SERVICE ADVISORY 17-298

SERVICE ADVISORY # 17-298

Springdale 38BH Bunk Support

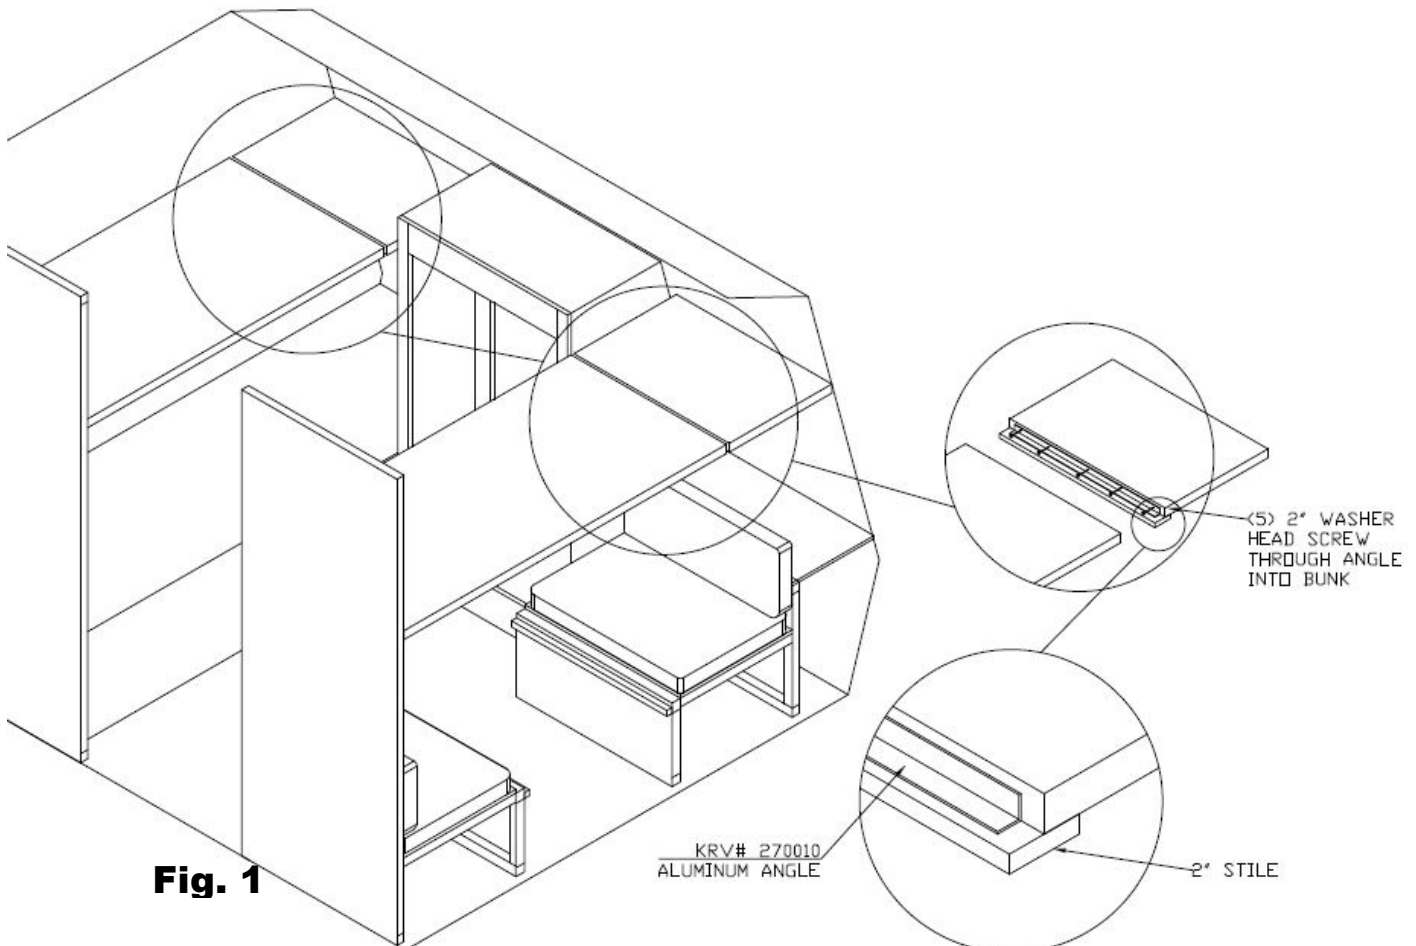
It has been determined some 2018 Springdale 38BH models were built with support that may be inadequate for the rear upper bunks, additional support must be added. This service advisory explains how to add additional fasteners.

Locate the support for the upper bunks in the rear of the unit, Figure 1.

Cut aluminum angle (270010) to fit existing support and install according to Figure 1, using 5 screws in each support as indicated.
